Evaluation of Proposed Park Improvements from 2012 La Plaza Vieja Draft Plan

Recommendation 2.1: Old Town Springs Park

Recommendation 2.2: Clay Avenue Ball Park

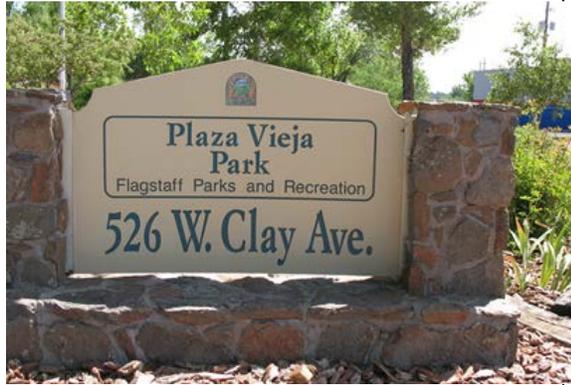
2012 Recommendation	2014 Evaluation
Redesign parking to be more efficient	The parking area is currently a dirt lot. It could be paved and striped with parking spaces. On-street parking is available in addition to the lot.
Allow pedestrian access from south	Would require agreements with property owners, and an easement would be needed for pedestrian access across parcels. This issue could be considered along with improvements to FUTS access in the neighborhood.
Shared parking with apartments to the south?	This would require agreement with the apartment complex owner, and an easement would be needed for vehicle/pedestrian access between the two parcels. Also, peak hours for the park and the apartment complex coincide, so parking might not be available when needed.
Install flushing toilet facilities (not a port potty)	Determine if the porta-potties are an aesthetic issue or if a full amenity is desired. If a full amenity is desired, consider safety and maintenance issues: cost of heating the building so water pipes don't freeze, increased vandalism, vagrants staying overnight, etc. In the last few years there were complaints about the service vendor, but the City has since secured a new vendor.

Plant shade trees for playground area	Shade trees within the designated playground area are not possible, because the playground equipment requires "clear zones". There are spacing requirements for new shade trees that could make this difficult to achieve given the playground's proximity to private property. Also consider the tradeoff if space were to be taken from the parking area for planting.
Install dark-sky friendly lighting for evening games	Dark-sky friendly lighting is an opportunity at this park location. Funding would most likely need to be supplemented in addition to what Parks & Rec could provide.
